Design Change Notice

Document: dcn190902_new
MB100x750 design

New design: Motorbase MB 100 x 750, Part no. 02 200 900

MB 100 new with one solid motor plate, delivered in “off-set” configuration:

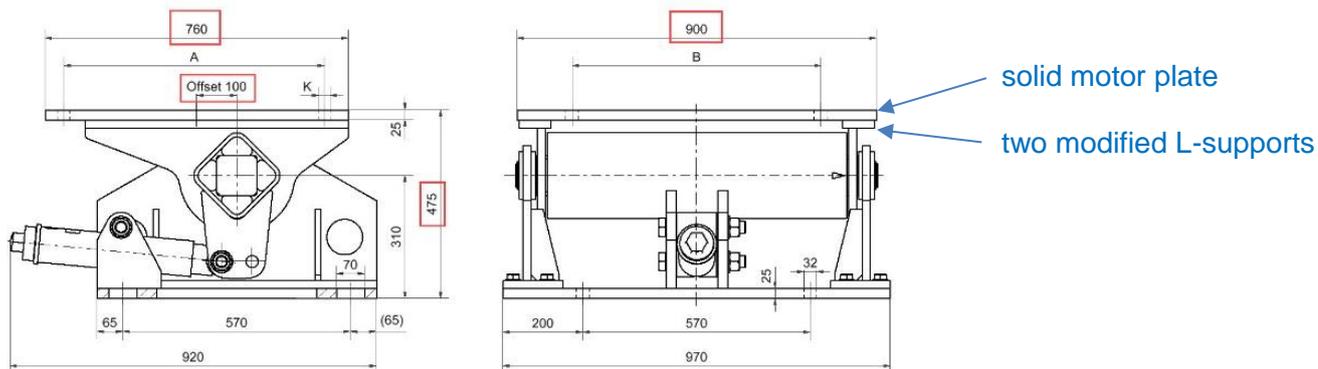
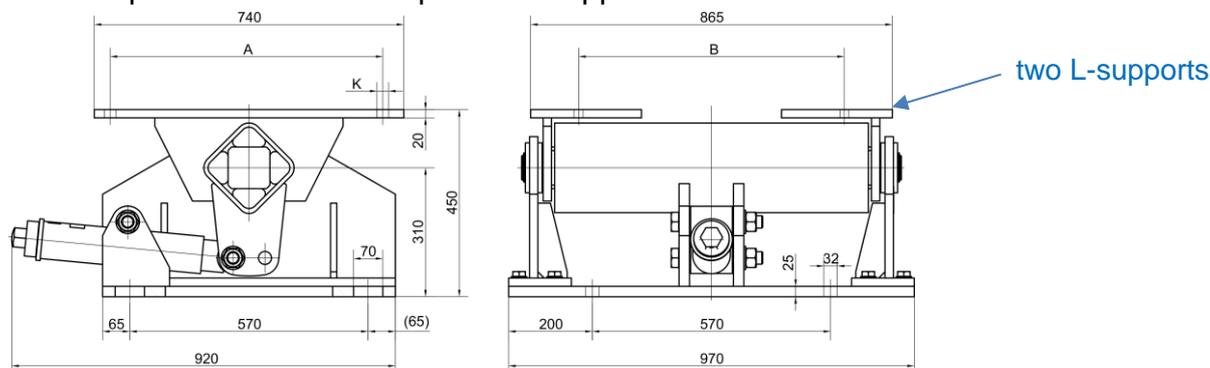
ROSTA improved the handling of the Motorbase MB 100 by adding a solid motor plate.

- The MB 100 has now a solid motor plate
- The part no. stays the same
- Form, fit and function is mostly equal to the previous MB 100 versions, the small deviations are shown below:

The red markings indicate the small differences.
